PROPOSAL FOR DRAFT AMENDMENTS TO THE 02 SERIES OF AMENDMENTS TO
REGULATION No. 46

(Devices for indirect vision)

Transmitted by the expert from the European Commission (EC)

**DETERMINATION OF THE OCULAR POINTS FOR A SEAT
WITH A FIXED SEAT-BACK ANGLE**

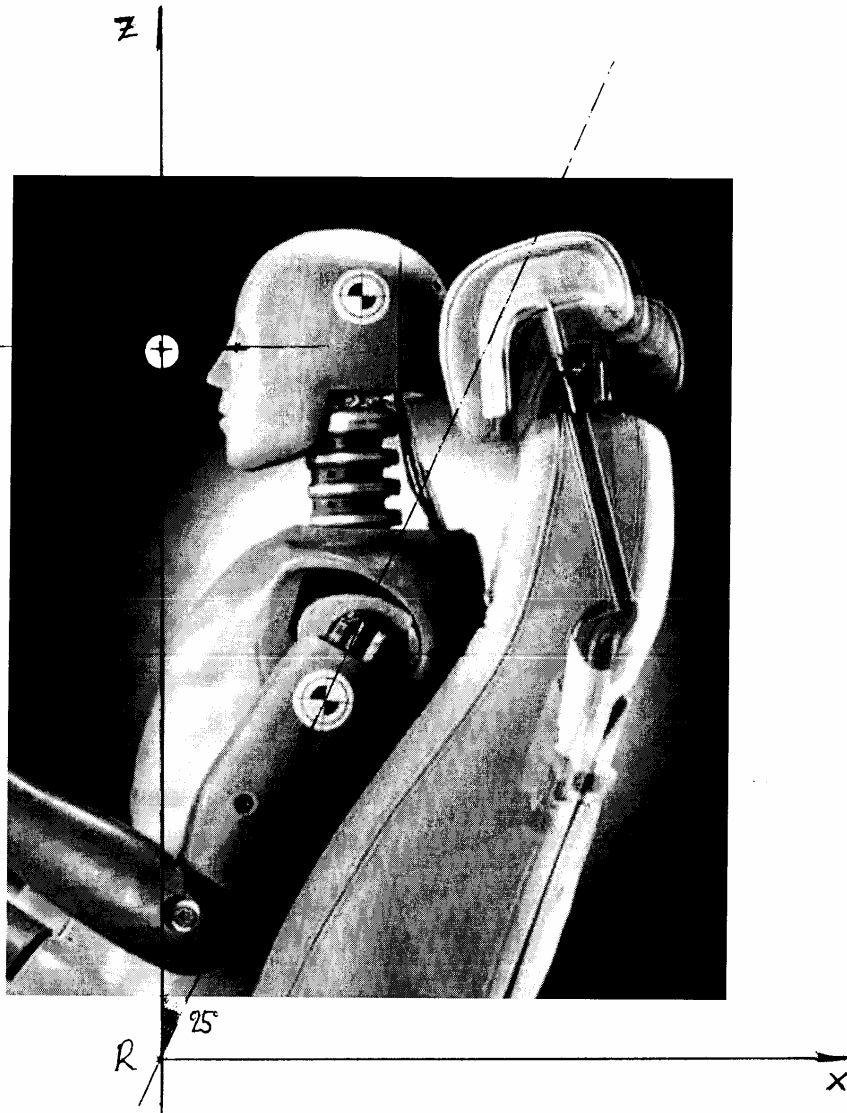
For the purpose of calculation, it is assumed that the location of the ocular points set up at 635 mm above the R point corresponds to a seat back angle inclined by 25° and that the height of the eyes with respect to the body does not change if the seat back is moved from 5 to 40° (which implies in turn that the position of the head does not change). Therefore, it can be assumed that the ocular points will run a circular travel around the R point when the seat back moves from 5 to 40°. This is a simplification because the movement of seat back would not follow the same law as the dummy (e.g. hybrid III dummy or 3 D-H machine).

Coordinates of the various positions of the O points can be calculated from the equation

$$X^2 + Z^2 = 635^2$$

and the variations ΔX ΔZ , deduced by using simple trigonometric functions.

When testing the field of vision in the case of a fixed sat back angle which is different from 25° , the light sources have to be positioned in accordance with the adaptations calculated by the method described here above (see diagrams for details).

Principe du calcul Δz & Δx .

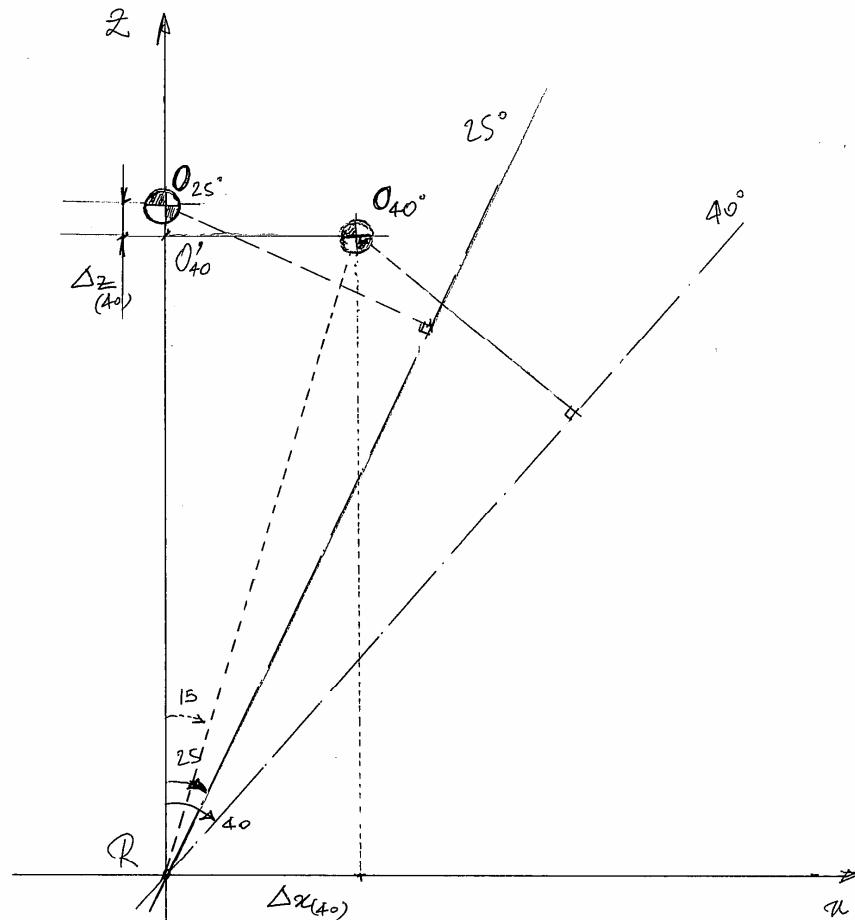
$$R_0 = 635 \text{ mm.}$$

$$R_{O_{40}} = 635 \times \cos 15^\circ$$

$$\Rightarrow \Delta z_{(40)} = -635(1 - \cos 15) = -21,637.$$
